Comments on 2014 IRP Technical Conference Analysis Results

**Paul Chernick
Resource Insight
19 September 2014**

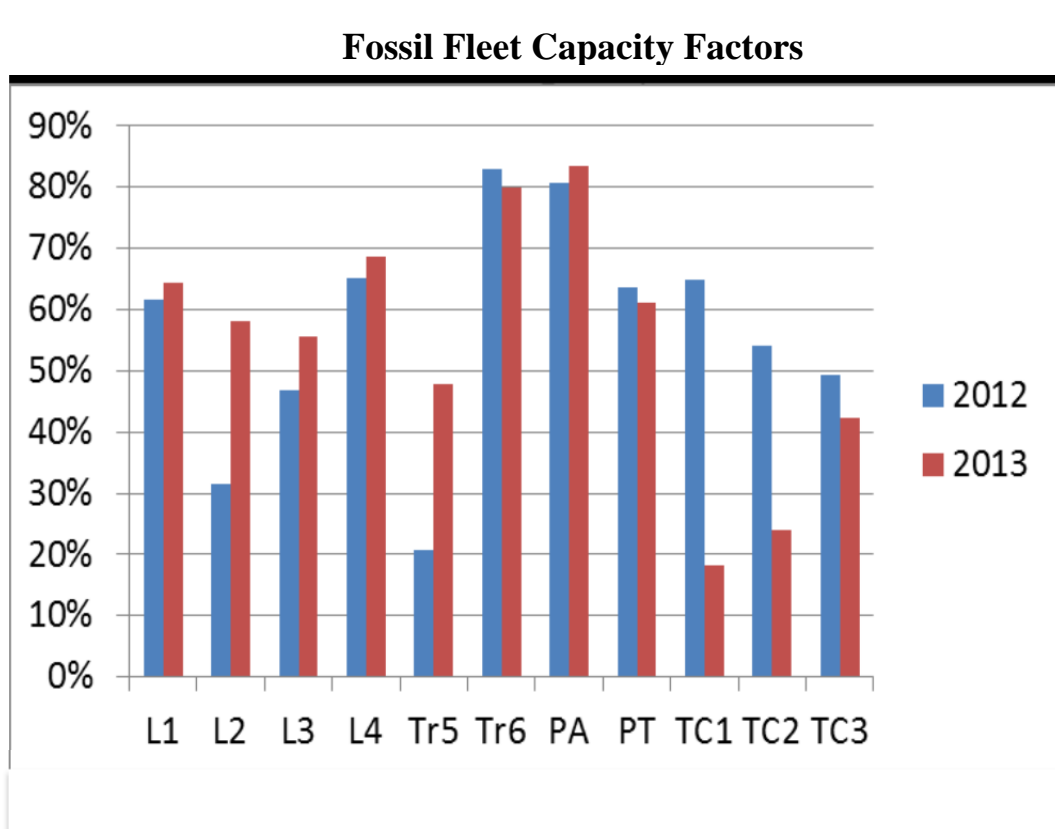
Yet historically, Trenton 5 has run less than most or all of the Lingan units, as shown in this figure from the 2012–2013 FAM Audit. Since Trenton 5 was out of service for seven months in 2012 (March–September), its capacity factor was depressed. But since Trenton 5 operates primarily in the winter, it is not clear how much higher its capacity factor would have been without the outage.

The operating expense filings and the fuel updates from the last two GRAs and Figure 230 of the GE Nova Scotia Renewable Energy Integration Study support the conclusion that Trenton 5 generally runs less than the Lingan units.

The IRP should explain why NSPI is projecting that future dispatch order would be so different from historical dispatch.
